COMPUTIME LTD.				
DRAWN:ZJ SONG	DATE:Feb 10,06	SUN006A10A(RF-RX)		
CHK:	DATE:	A3	RF PART	REV:03
APP:	DATE:	SCALE:NONE		
RELEASE:	DATE:	SHEET:2 OF 4

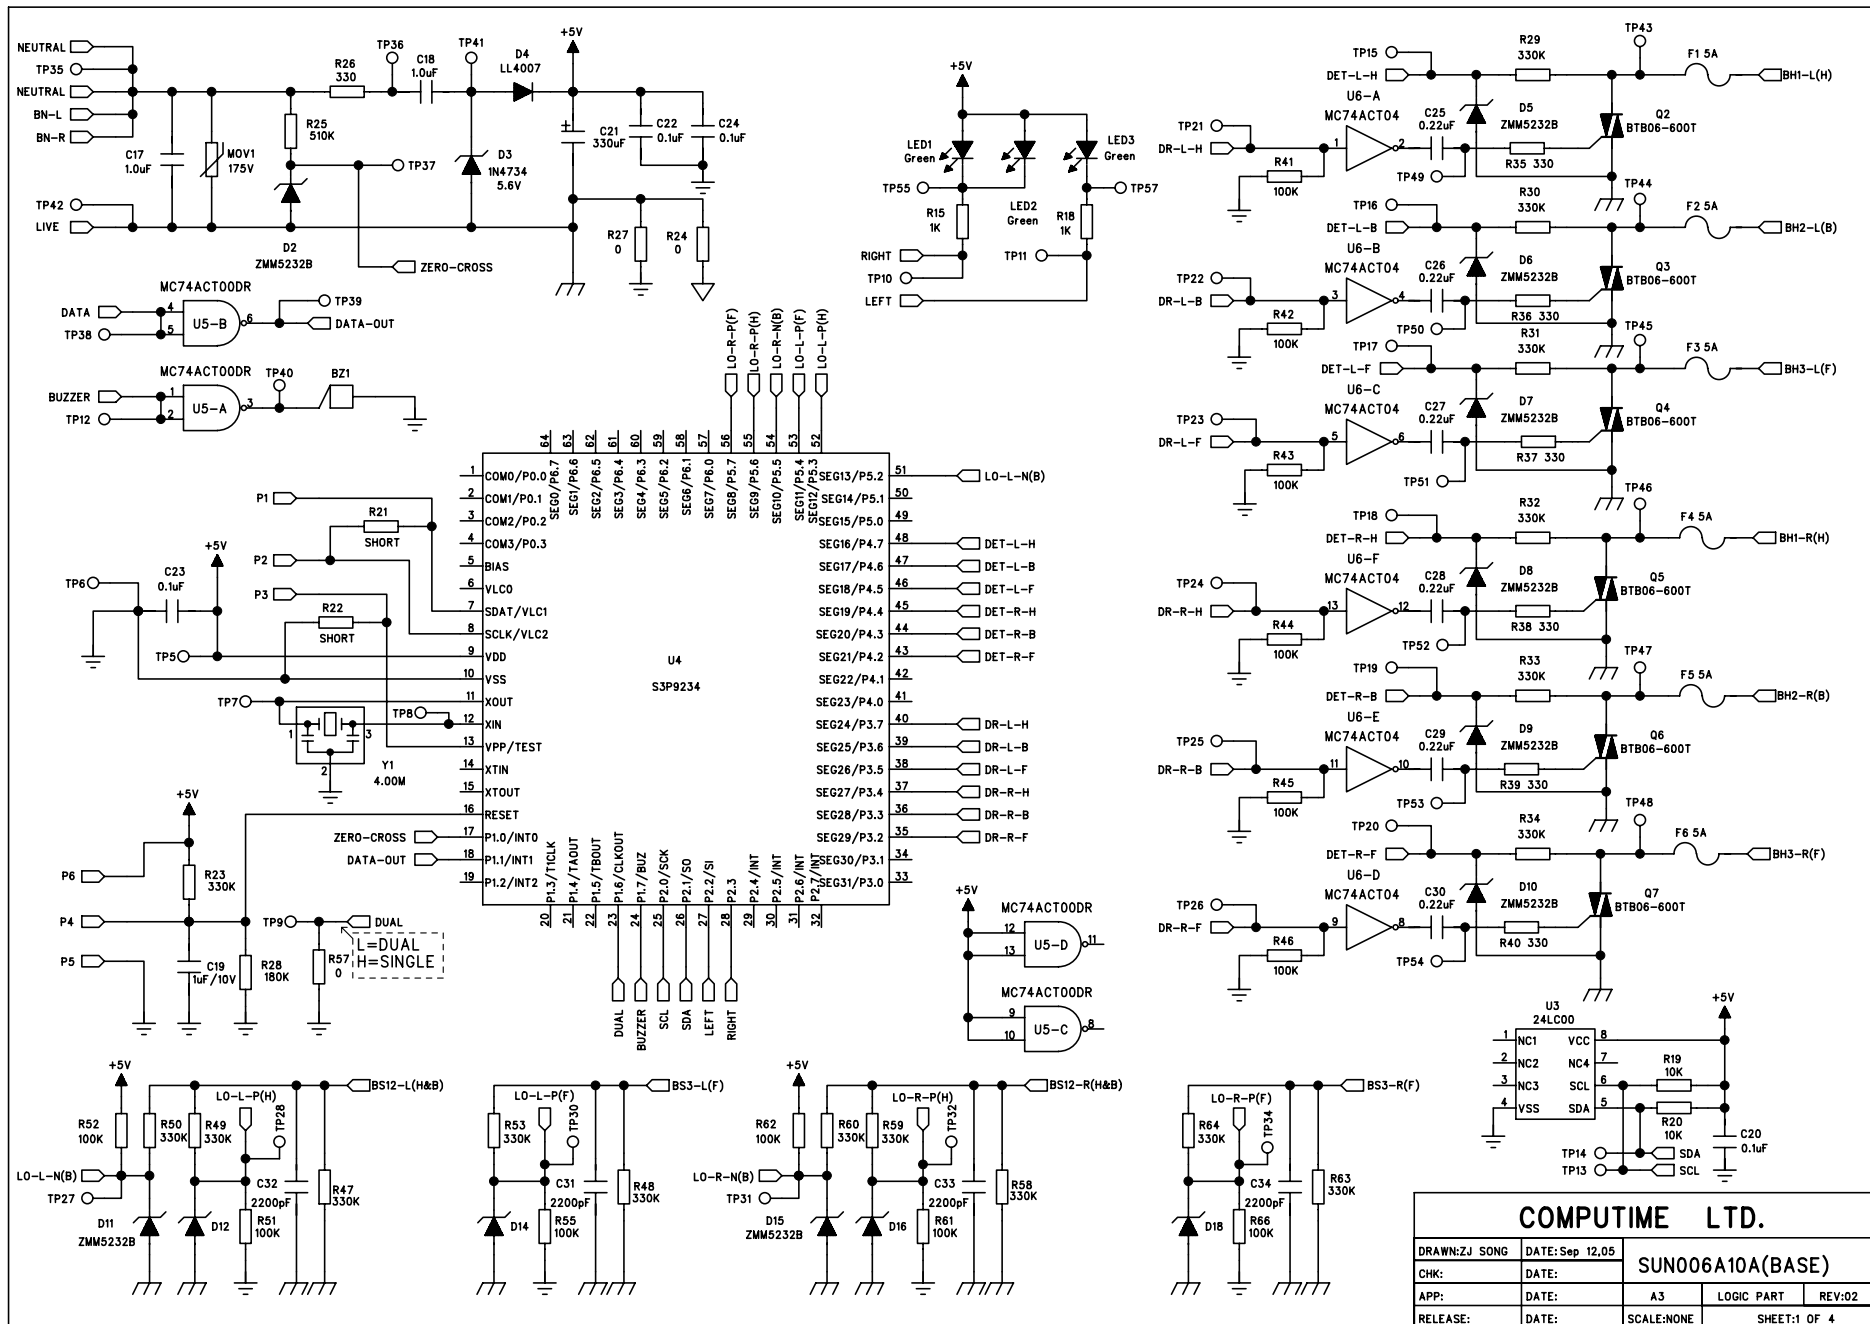
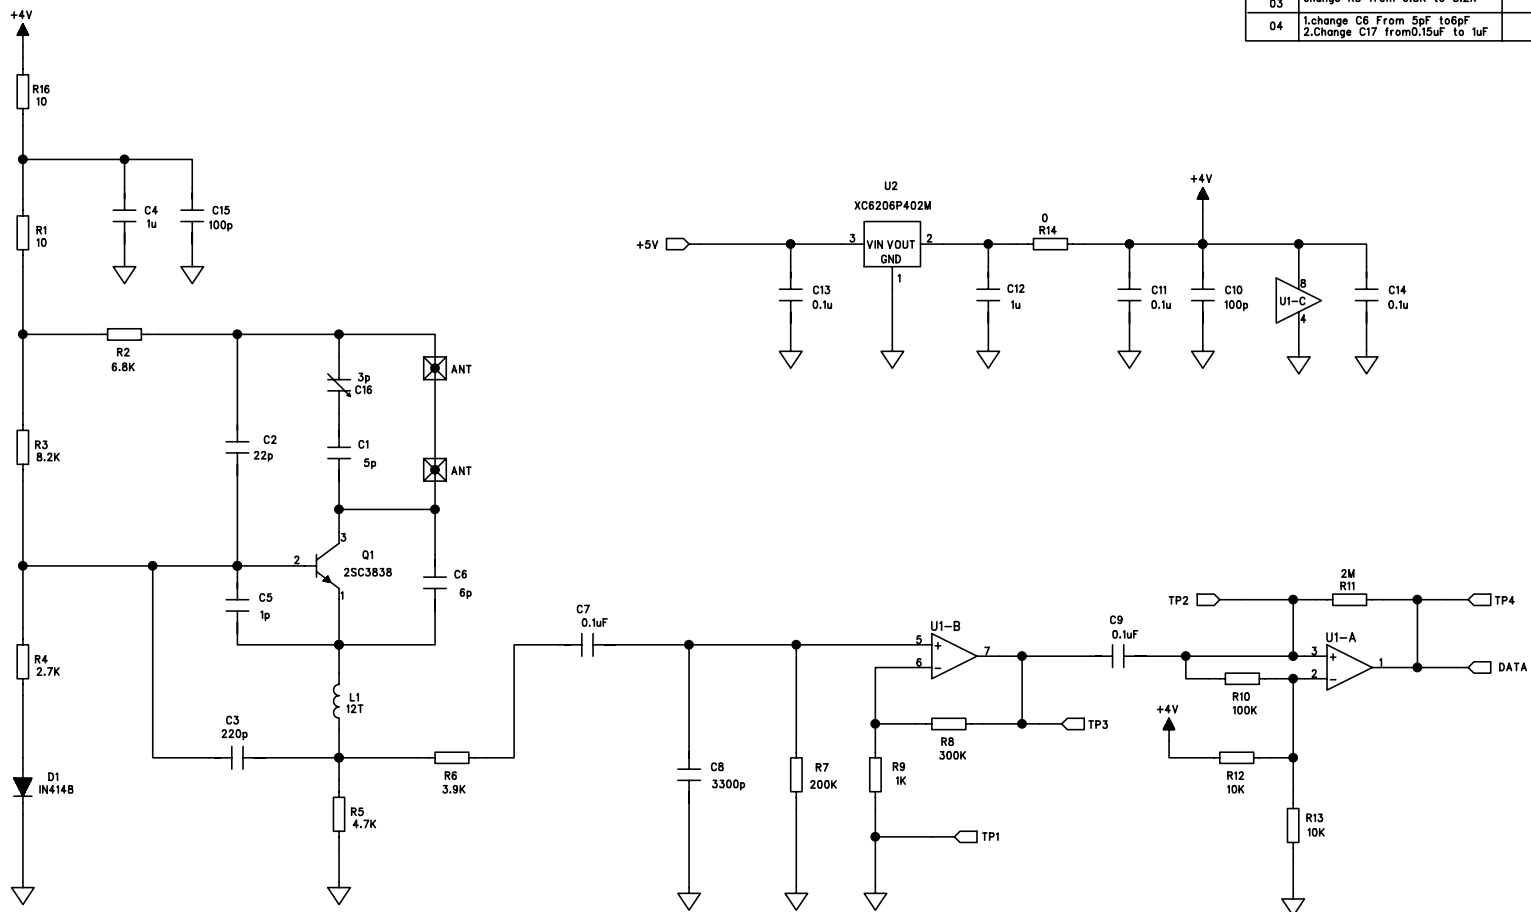
REVISION RECORD			
REV	Change description	APPROVED:	DATE:
01	Original		Dec.29,04
02	change C7 and C9 from 1uF to 0.1uF		Sep.12,05
03	change R3 from 6.8K to 8.2K		
04	1.change C6 From 5pF to6pF 2.Change C17 from0.15uF to 1uF		Mar. 27,06
